# Muswellbrook Waste Transfer Station

## Road Safety Review

Prepared for: Muswellbrook Shire Council  
23 June 2022

Figure 8: Extract from DA 2021-55 Environmental Impact Assessment Final - PAN-97898 Figure 4.6

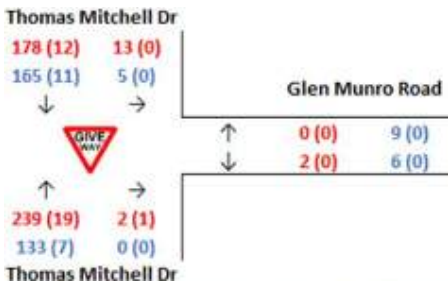
Using the traffic survey undertaken by EMM on the 24<sup>th</sup> November 2020 (extract shown in Figure 8) and the expansion factor in “*principles and guidelines for economic appraisal of transport investment*” for Rural peak 1 hour (pm) to weekday of 12.10, we get an ADT of **5,046** with a HV% of **7.4**.

It is noted that the additional traffic generated by the development will increase the risk of crashes at the intersection (by increase the likelihood) of Thomas Mitchell Drive and Glen Munro Road.

Figure 13: BAR Layout

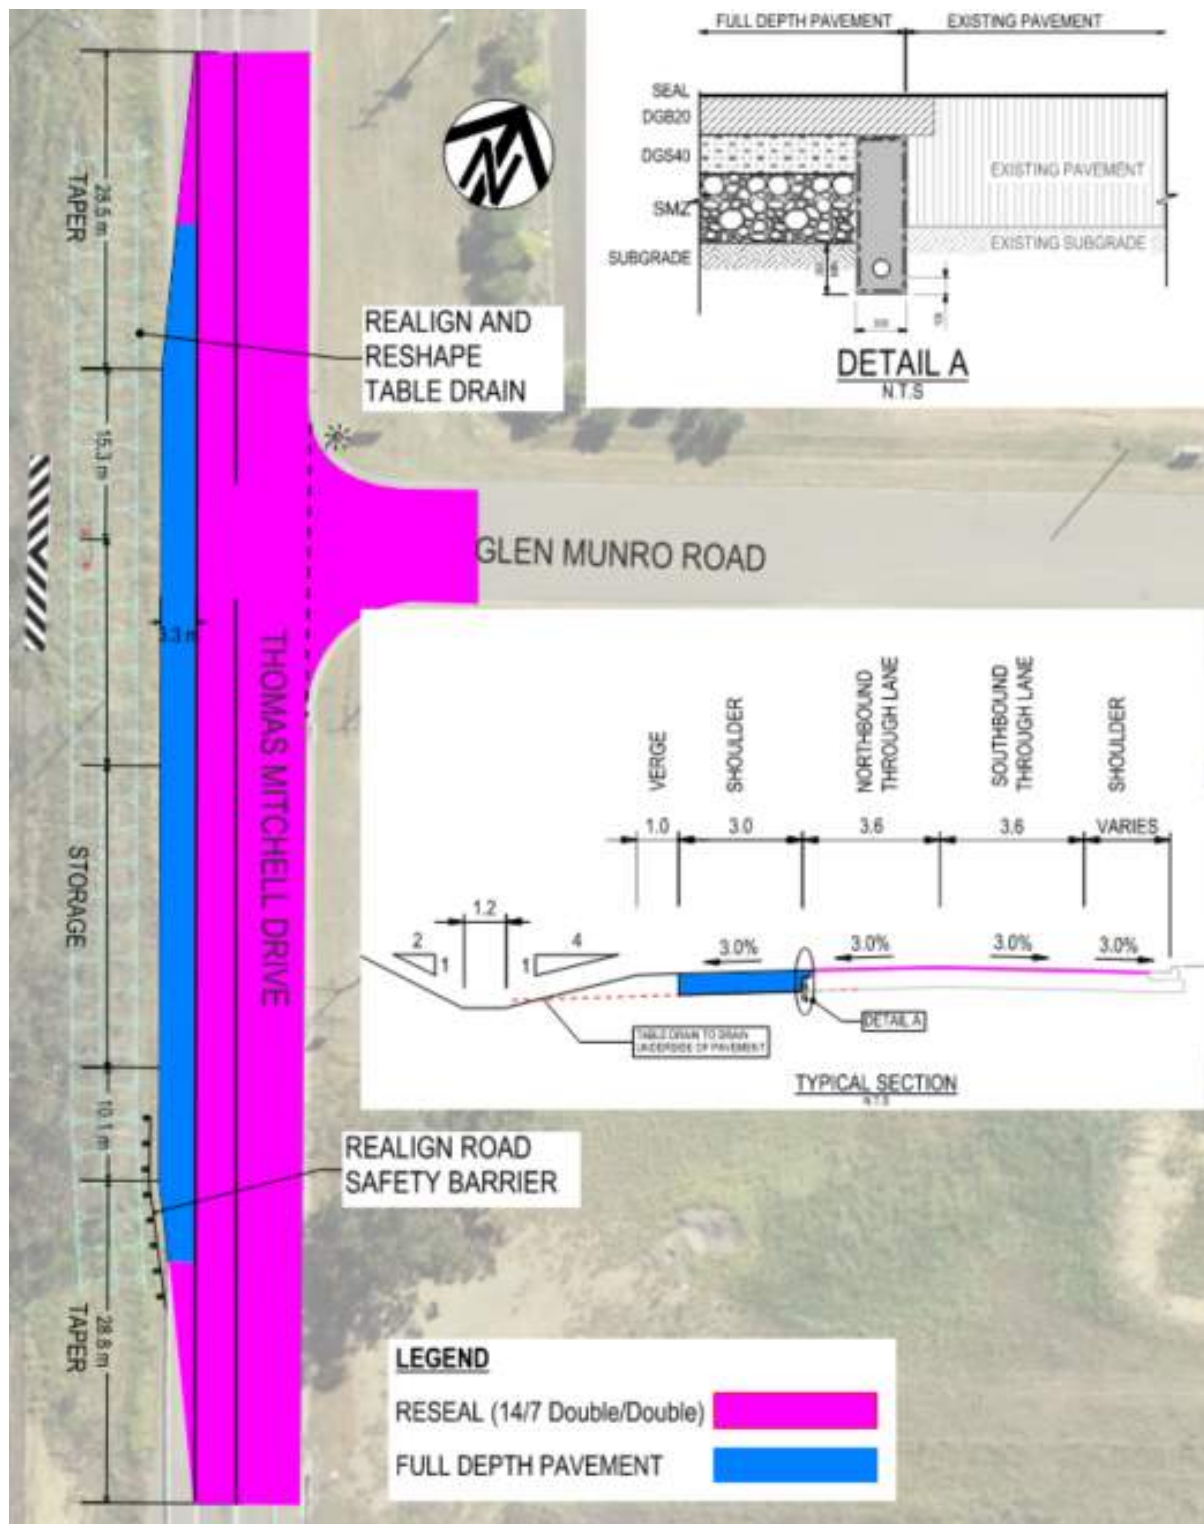
To improve SSD the road safety barrier would need to be modified (set-back from the edge of the road). Modifying the location of a road safety barrier can have affect the barriers performance (higher impact angles) and any changes would need to be carefully considered. Note providing adequate SSD does not eliminate the risk of rear-end crashes. Another solution, which would be the preferred, would be to provide space for a vehicle to overtake a waiting vehicle. This mitigation measure would significantly reduce the likelihood of rear-end crashes as it would provide space to a vehicle to manoeuvre around the waiting vehicle if it was late seeing the waiting vehicle. This is in essence a BAR which is discussed in the next section.

The basic right-turn treatment (BAR) is the minimum treatment recommended by Austroads for "right-turn movements from a through road to side roads and local access points. This treatment provides sufficient trafficable width for the design through vehicle to pass on the left of a stationary turning vehicle. This is achieved by widening the shoulder to provide a minimum width sufficient to allow vehicles to pass. Substantial speed reduction (half of the design speed) is a feature of this layout. See Figure 13 to see how this would be applied to the Thomas Mitchell Drive and Glen Munro Road intersection.

Figure 15: Channelised right-turn treatment with short turn slot [CHR(S)]

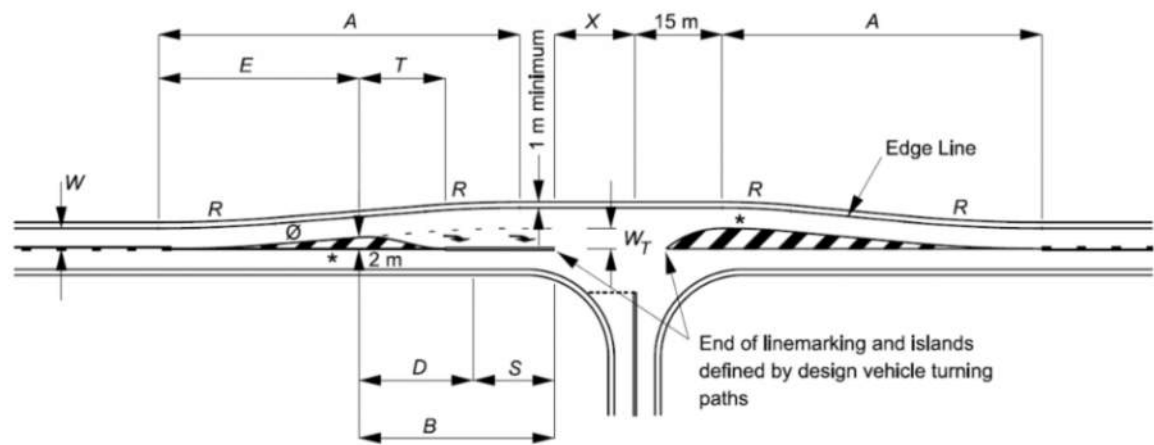
- The existing streetlighting is flag light and although it highlights the location of the intersection it does not illuminate all the possible conflict points. If the streetlight was upgraded to provide V3 lighting at all the conflict points it would improve the safety of the intersection.
- The BAR turn treatment on a two-lane rural road as shown in Figure 13 has limited applications. It is mainly applicable at the junction of side roads and rural arterial roads with lower traffic volumes. Such turn treatments can record high crash rates, especially in high-speed areas. If in the future traffic volumes especially HV turning volumes increase a more desirable treatment would be a CHR(S) turn treatment discussed in Section A.16 of

AGRD Part 4 and as show below in Figure 15
